## IEEE 802.11

#### Proposed Text for Section 4 Based on responses to Draft D1 Letter Ballot processed at May, 1995 Meeting of IEEE P802.11

**Abstract:** This paper presents the changes to section 4 in the Draft Standard P802.11/D1 as a result of the Response to Draft D1 Letter Ballot processed at the May, 1995 meeting of IEEE P802.11.

**Action:** Adopt the changes in this paper to replace the relevant portions of P802.11/D1.1.

Figure 4-2: Frame Control Field

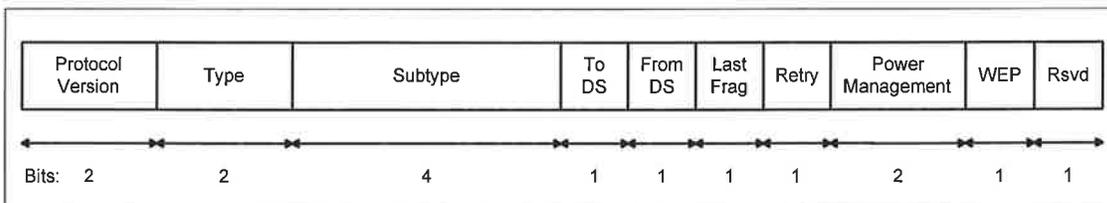
The Frame Control field shall consist of the following sub-fields: Protocol Version, Type, Subtype, To DS, From DS, Last Fragment, Retry, Power Management and WEPElements Present. The remaining subfields in the Frame Control field are reserved. All reserved bits and fields shall be set to ~~set to~~ as '0'. Reserved bits and fields shall be ignored on reception.

**Figure 4-5: RTS Frame**

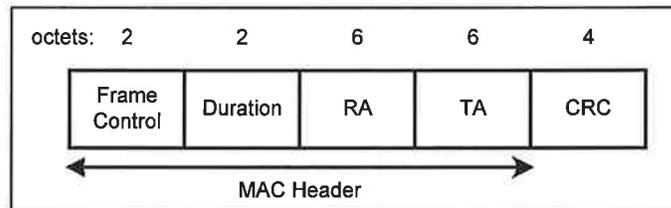
The frame format for ~~the~~an RTS frame ~~shall be as defined~~is shown in Figure 4-54.

The RA of the RTS frame shall be the address of the STA, on the wireless medium, that is the intended immediate recipient of the pending directed Data or Management frame.

The DA of this frame shall be the address of the immediate station receiving the frame. In an infrastructure LAN, the DA shall be the address of the AP with which the station is associated. In an ad hoc LAN, the DA shall be the destination of the subsequent data or management frame. The SA shall be the address of the station transmitting the frame.

Figure 4-65: CTS Frame

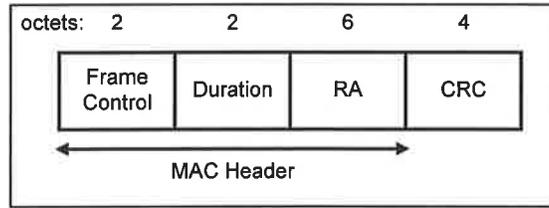
The frame format for the CTS frame shall be as defined in Figure 4-65.

The Receiver destination Address (RA) of the CTS frame shall be copied taken from the Transmitter source Address (TA) field of the immediately previous RTS frame to which the CTS is a response.

Figure 4-76: ACK Frame

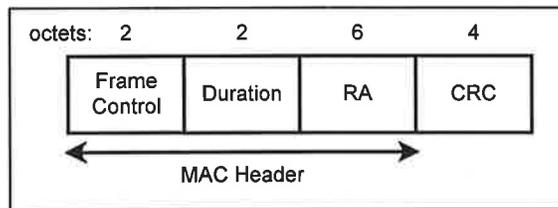
The frame format for the ACK frame shall be as defined in Figure 4-76.

The Receiver Address DA of the ACK frame shall be copied from the address contained in the Address 2 field of the immediately previous directed Data or Management frame.

Figure 4-87: PS-Poll Frame

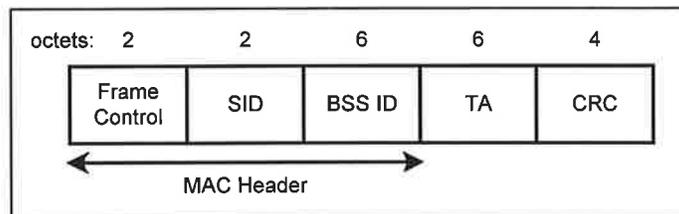
The frame format for the Power Save Poll (PS-Poll) frame shall be as defined in Figure 4-87.

The BSS Identifier shall be the address of the STA contained in the AP. The Transmitter Source Address (TA) shall be the address of the STA station transmitting the frame. The SID shall be the value assigned by the AP in the Associate Response frame.

Figure 4-118: DATA Frame

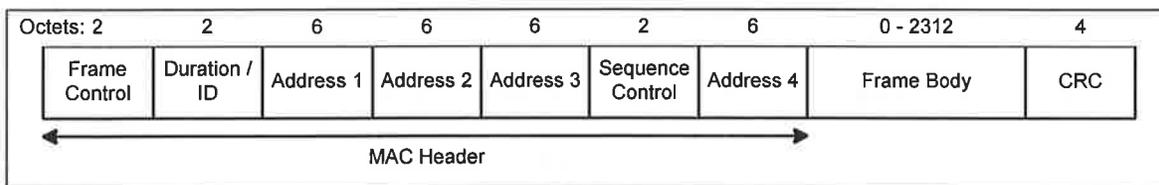
The frame format for a Data frame is independent of subtype and shall be as defined is shown in Figure 4-118.

The DA shall be ~~the destination of the frame, i.e. the destination of the MSDU (or fragment thereof) in the frame body field.~~

The SA shall be the address of the ~~MAC entity~~ station initiating the transmission of the MSDU (or fragment thereof) in the frame body field, transmitting the frame.

The RA shall be the address of the ~~STA contained in the AP access point~~ in the wireless distribution system that is the next immediate intended recipient of the frame.

The TA shall be the address of the ~~STA contained in the AP access point~~ in the wireless distribution system that is transmitting the frame.

**Figure 4-129: Management Frame Format**

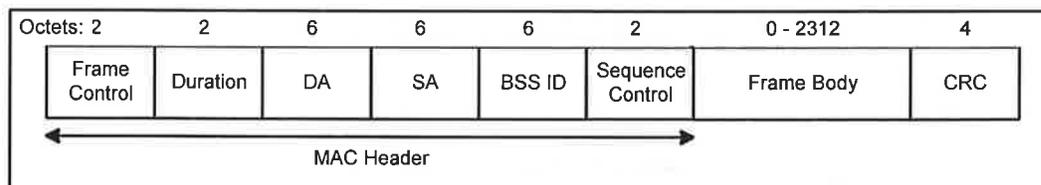
The frame format for a Management frame is independent of subtype and shall be as definedis shown in Figure 4-129.
